Access Compliance Report

(Curb Ramps)

Intersection ID: 27530	Main Street: BALLANTYNE_COMMONS_PY	Cross Street: BALLANTYNE_FOREST_DR	Location: SE
ADA ID: D3AD5C705493	Ramp Type: Perp	Initial Pass/Fail: Fail	Overall Compliance: No
Severity Score: 13.75			
Codes/Mitigation Info/Possible Solution		Field Measurements/Component Compliance

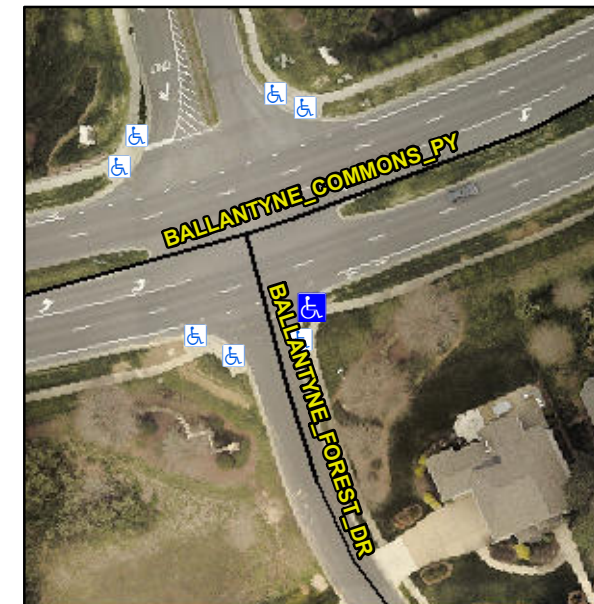
R304.2.2, R304.5.3

Compliance	Description	Data	Compliance	Description	Data
N/A	Ramp Length (in)	45.0	No	Ramp Slope (%)	8.6
Yes	Ramp Width (in)	51.0	No	Ramp XSlope (%)	3.7
N/A	Flare Type LT	N/A	N/A	Flare Type RT	N/A
N/A	Flare Slope LT (%)	N/A	N/A	Flare Slope RT (%)	N/A
N/A	Flare Traversable LT?	N/A	N/A	Flare Traversable RT?	N/A
N/A	Landing Length (in)	N/A	N/A	DWS Provided?	N/A
N/A	Landing Width (in)	N/A	N/A	DWS Contrast?	N/A
N/A	Landing Slope (%)	N/A	N/A	DWS Length (in)	N/A
N/A	Landing X Slope (%)	N/A	N/A	DWS Full Width?	N/A
N/A	Landing Curb? (Y/N)	N/A	N/A	DWS Offset (in)	N/A
N/A	Shared Landing?	N/A			
N/A	Gutter Ponding?	N/A	N/A	Gutter Slope (%)	N/A
N/A	Gutter Lip Ht (in)	N/A	N/A	Gutter X Slope (%)	N/A
N/A	Painted X Walk1?	No	N/A	Painted X Walk2?	N/A
	X Walk 1 Direction	To NE		X Walk 2 Direction	N/A
N/A	X Walk 1 Width (in)	N/A	N/A	X Walk 2 Width (in)	N/A
	X Walk 1 Slope (%)	5.2		X Walk 2 Slope (%)	N/A
	X Walk 1 X Slope (%)	1.1		X Walk 2 X Slope (%)	N/A

Remove & Replace Entire Ramp.
